Project No. G1933-42-05  
June 16, 2021

Subject: RESPONSE TO CITY REVIEW COMMENTS/UPDATE LETTER  
BDM MIX-USE  
(HANDLER COMMERCIAL)  
DRAWING NO. 39191-19-D  
OTAY MESA ROAD AND CORPORATE CENTER DRIVE  
SAN DIEGO, CALIFORNIA

**GEOLOGIC MAP**  
HANDLER COMMERCIAL  
SAN DIEGO, CALIFORNIA

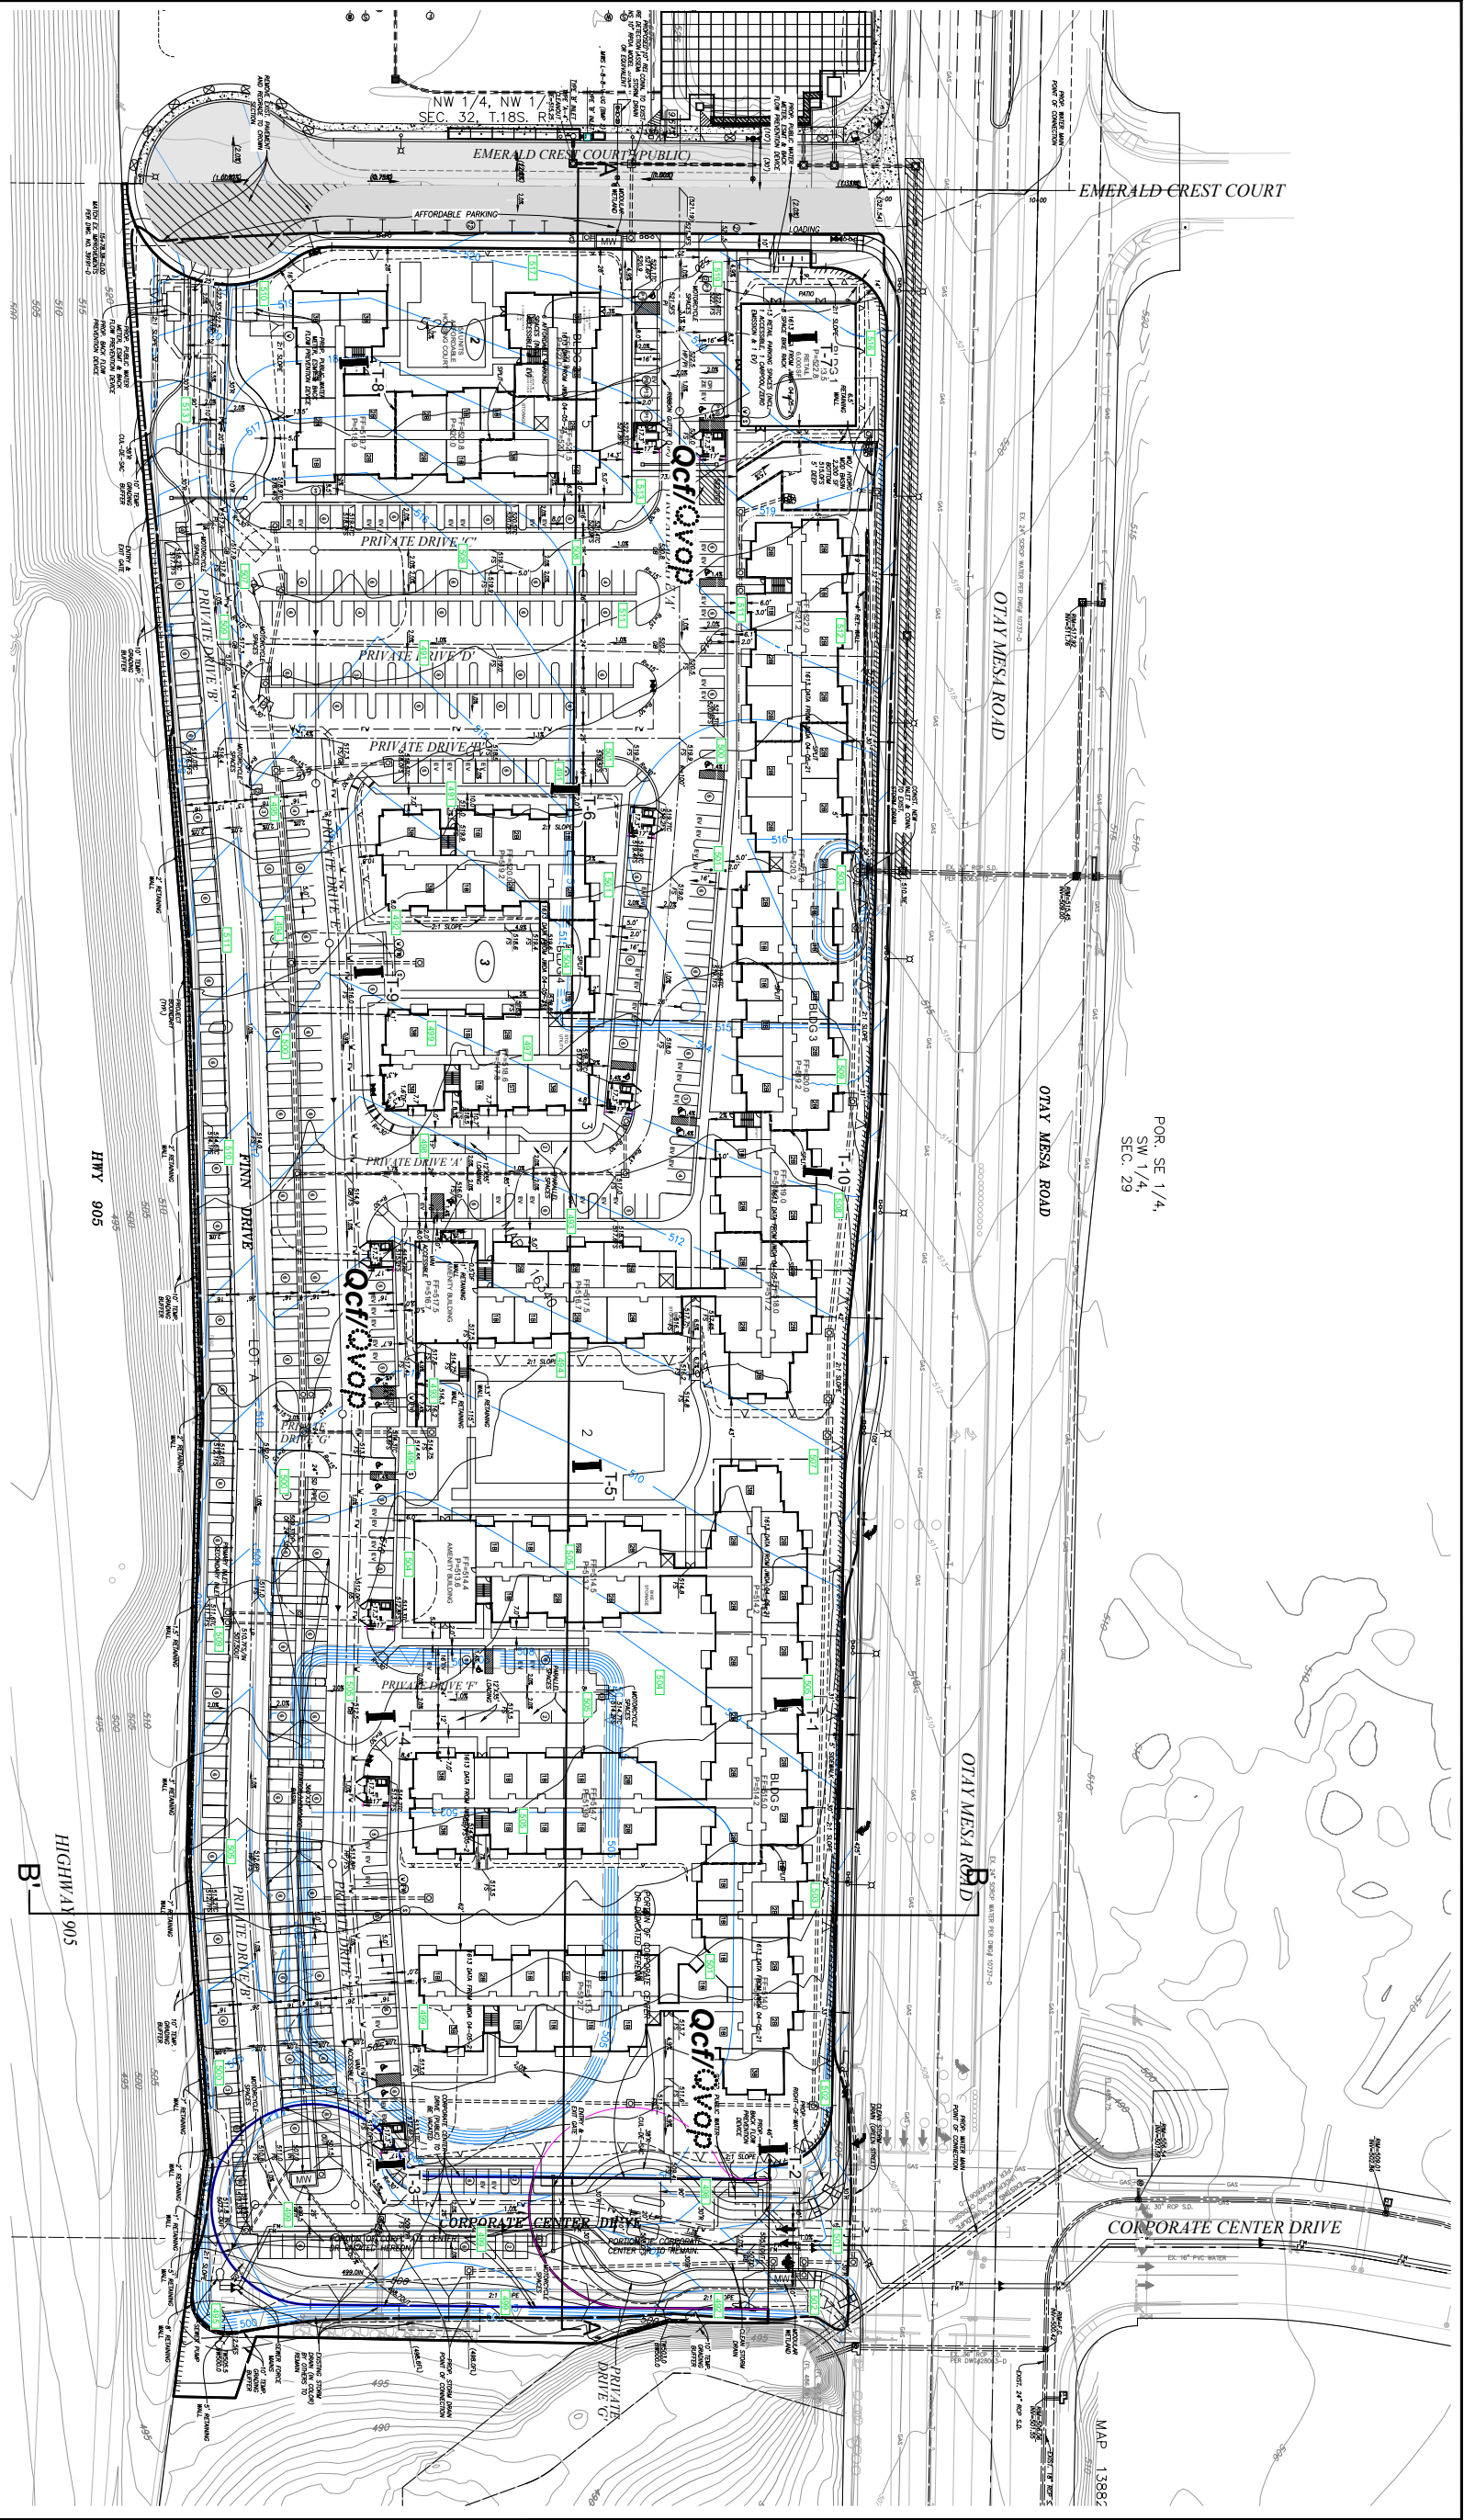
**Comment No. 3** *Provide an updated geologic/geotechnical map that shows the distribution of fill and geologic units, location of exploratory excavations and current development/project on a topographic base map.*

**Response:** The updated geologic/geotechnical map is attached as Figure 1.

**GEOLOGIC CROSS - SECTIONS A-A' & B-B'**  
HANDLER COMMERCIAL  
SAN DIEGO, CALIFORNIA

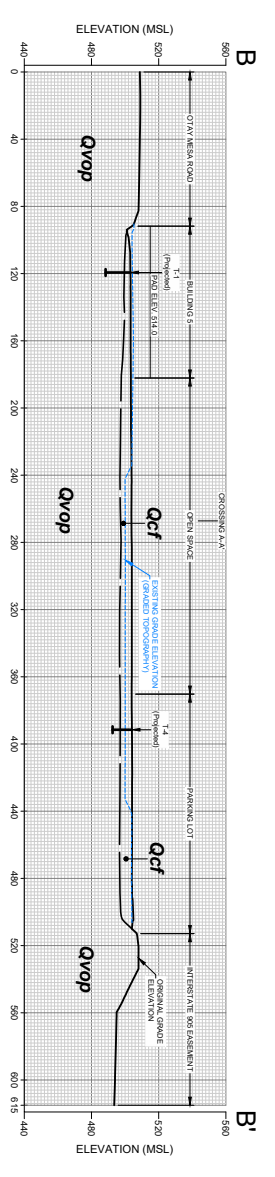
**Comment No. 4:** *Provide updated geologic/geotechnical cross-sections representative of the site conditions which depict the existing and proposed grades based on the current proposed development/project.*

**Response:** Updated geologic/geotechnical cross-sections are attached in Figure No. 2.
